PRECISION **INTERNATIONAL**

KEY UPDATES

Powertrain
expo 2026

PI Part #: 37614

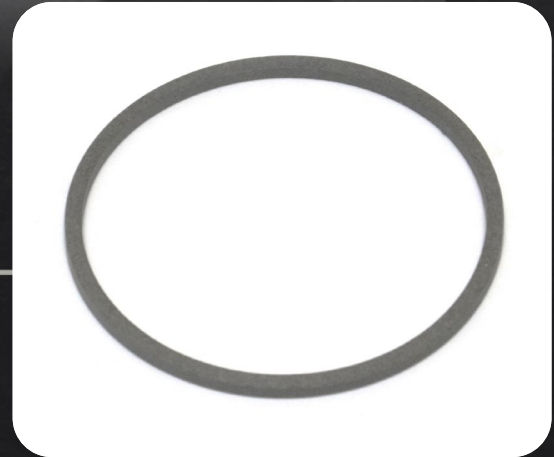
10R80 INPUT SHAFT, DIRECT/OD SEALING RING DESIGN CHANGES:

2-Input Shaft -Large (5 pcs.)

Was PI# 33614 Ford# HL3Z-7G091E 1.645" OD X .083" TH X .085" RW

Now PI# 37614 Ford# HL3Z-7G091-G 1.630" OD X .082" TH X .083" RW

RE5R05A, RE7R01A/B CENTER SUPPORT/REVERSE BRAKE DRUM SEALING RINGS UPDATE

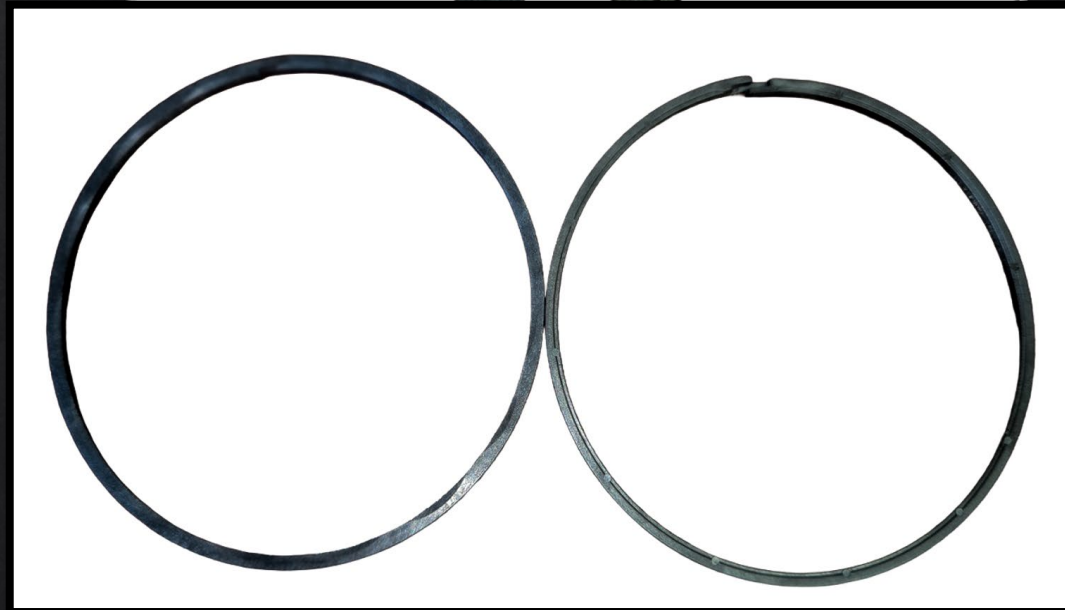
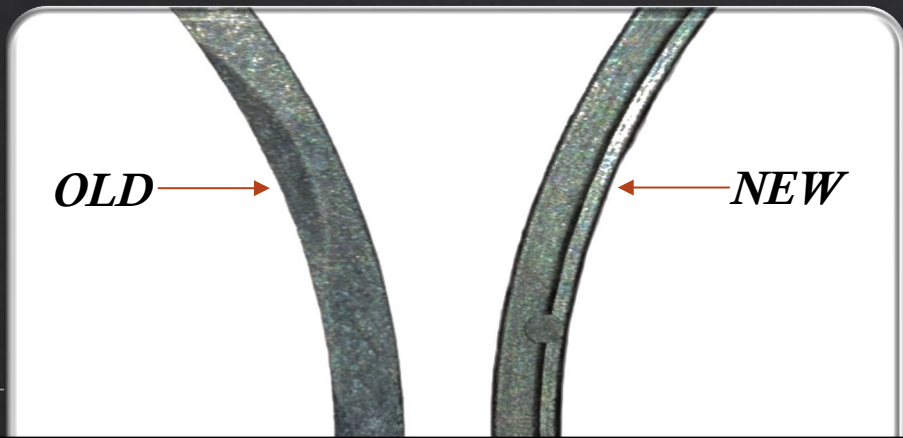
The “scalloped” version (62907, Nissan # 31525-90X07, Subaru 31377-AA230) was replaced by the “flat-edged” or “ridge” version (62587, Nissan # 31525-1XJ0B) in May 2024 here at Precision. This was triggered by the OEM supersession of the 31525-90X07 to 31525-1XJ0B by Nissan. The “flat-edged” style retrofits the “scalloped” one. This applies to all RE5, RE7 & Subaru 5-speed (all from the same Jatco platform).

NEW OE VALVE BODY NO MOVE, NO PRES

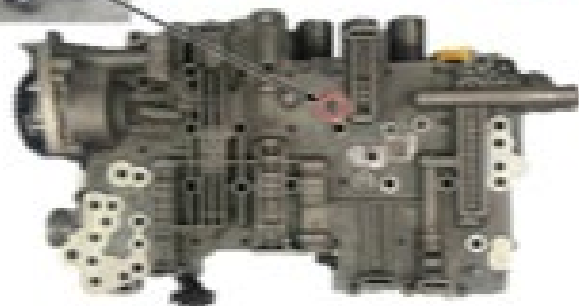
New OE valve bodies have what some GM techs call a test port. It is a plug bolted in a hole of new OE valve body that is different than the original VB. Occasionally a technician will think this plug should be removed. However, when the plug is removed it leaves a huge leak dumping line pressure.

Do not remove this plug that is in new OE valve body!
